DOCKETED	
Docket Number:	23-AFC-02
Project Title:	Elmore North Geothermal Project (ENGP)
TN #:	254833
Document Title:	Elmore North PDOC Comments and Exhibit A
Description:	N/A
Filer:	Alisha Pember
Organization:	California Unions for Reliable Energy
Submitter Role:	Intervenor
Submission Date:	3/4/2024 4:00:15 PM
Docketed Date:	3/4/2024

Re: **California Unions for Reliable Energy Comments on the Preliminary Decision to Grant a Preliminary Determination of Compliance for the Elmore North Geothermal Power Generation Plant**

**Subject: Comment Letter Elmore North Geothermal Project
Preliminary Determination of Compliance (PDOC).**

Figure 4: Existing Geothermal Sites Near ENGP

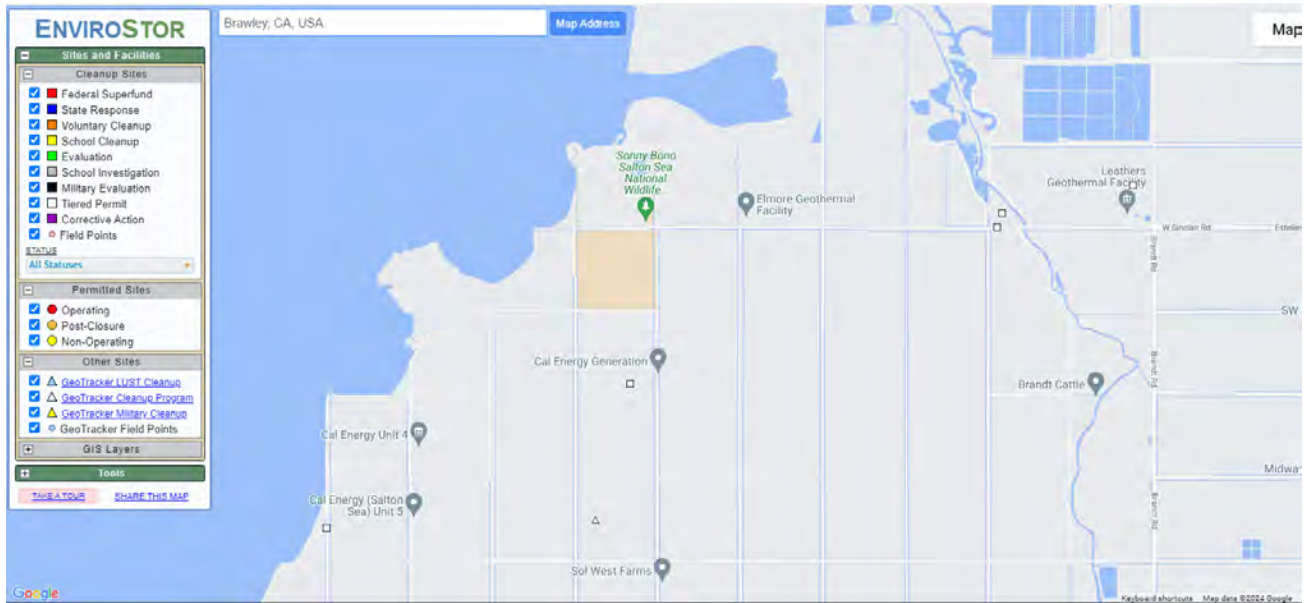
The PDOC ignores the emissions from the currently constructed geothermal plants in the vicinity of the ENGP. The geothermal plants include the CalEnergy Salton Sea Units 1 & 2/3&4/5

Facilities to the southwest of the ENGP, the CalEnergy JM Leathers Facility, the CalEnergy Central Services facility, the CalEnergy Vulcan/Del Ranch facilities and the existing CalEnergy JJ Elmore Facility.

The cumulative emissions of criteria pollutants (NO_x, SO_x, PM, CO, and lead) and air toxins (VOCs including benzene, toluene, diesel particulate matter, etc..) were not included in the Project evaluation. Given the designation of the area as a Disadvantaged Community under SB 535 and the non-attainment status of the Imperial Valley Airshed it is clear that there is a clear concentration gradient caused by the existing emissions into the community. Monitoring of particulate matter in the area shows higher concentrations PM₁₀ downwind of the Sonny Bono Salton Sea National Wildlife Reserve (in Calipatria) than at the Reserve. The primary difference in the PM results appears to be at least partly the emissions from the existing facilities.

Figure 6: IVAN Monitoring Stations Near Project Site

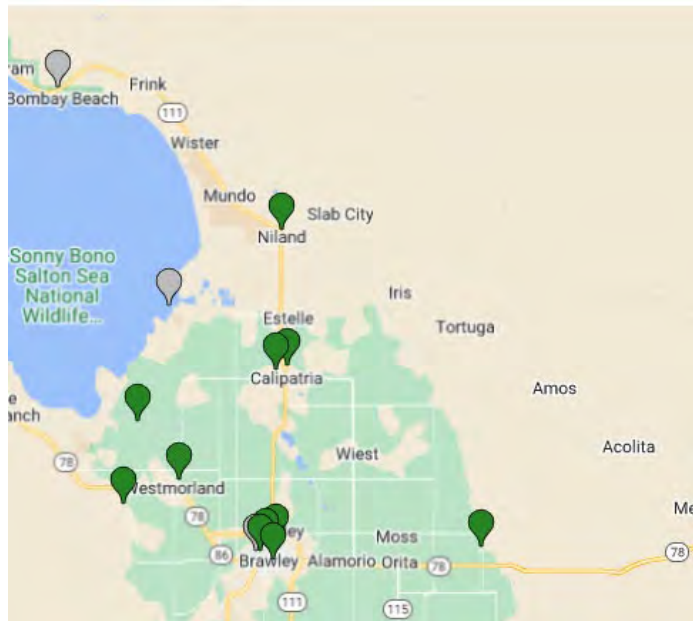
The application fails to identify 40 additional monitoring stations currently being operated in Imperial County. According to the Identifying Violations Affecting Neighborhoods (IVAN) website, IVAN Air Monitoring is a network of 40 air monitors located throughout Imperial County. As of September 2016, all but 7 of these monitors have been installed. The 13 closest IVAN stations to the Project Site are shown below in Figure 5.

The applicant should include all relevant monitoring sites in the background analysis of air quality to ensure that background concentrations are accurately reported for the region.
